Process Sheet

: MIRROR ARM

: D2010104

Subject: FW: R44 Mirror arm D2010-104

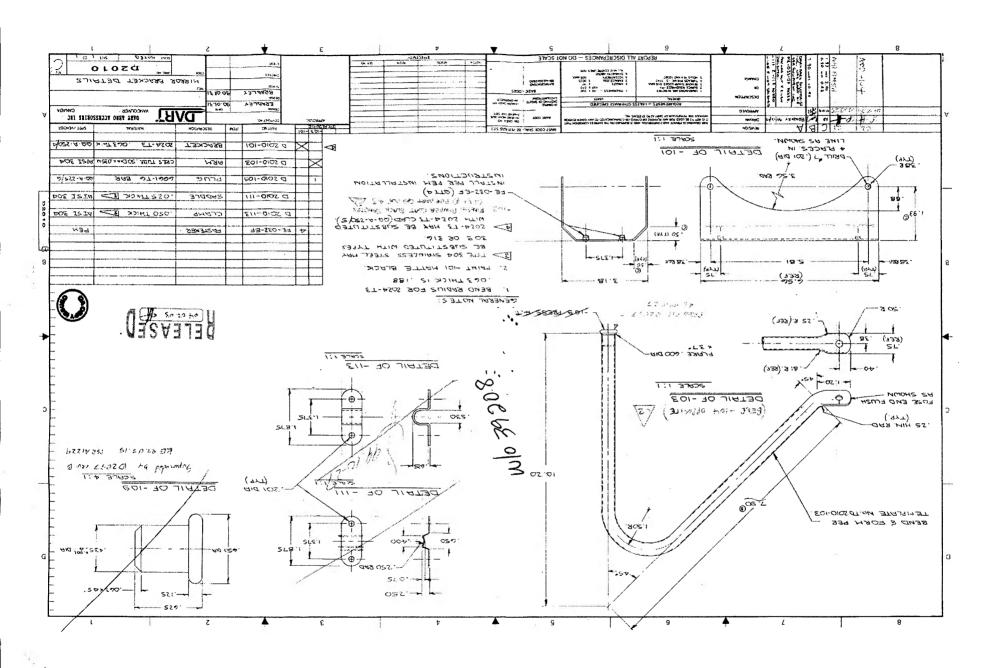
Chris - I suggest we make an arm with 0.049" wall vs. the 0.035" called up on the drawing, and that we sign this off as a deviation. If this is acceptable, please advise Linda ASAP.

We have been replacing the D2010-104 due to crack at the mirror attachment.

It is a weak point of the design.

| W/O: | | WORK ORDER CHANGES | | | | | | | | |
|-----------|------|------------------------|----|------|-----|-------------------------------------|--------------------------|--|--|--|
| C8.65.17_ | 1 | INSTEAD OF 0.035" WALL | | | | 08.05.12 08.042 | dut | | | |

This deviation is acceptable.
